■ TX-110C RF Chipset changed.

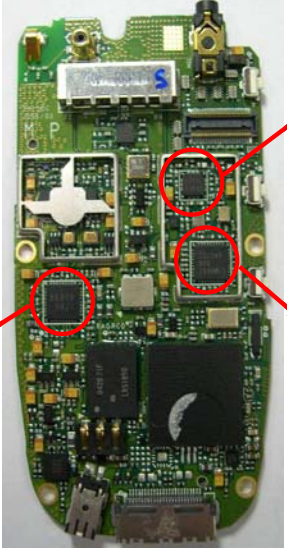
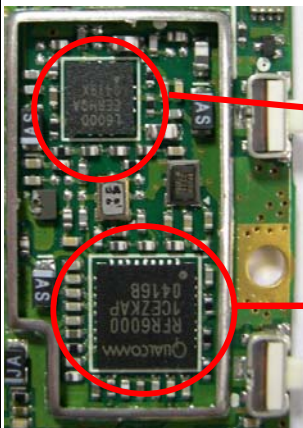
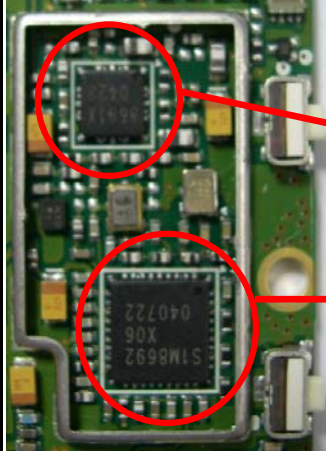
Location No.	Original(Qualcomm)	Changed(Samsung)
U610	RFL6000	S1M8691
U650	RFR6000	S1M8692
U750	RFT6100	S1M8690

Original	Changed
Vendor	Qualcomm(U.S.A)	Samsung(Korea)
Location info.		
Highlighted PIC. U610 / U650		
Highlighted PIC. U750
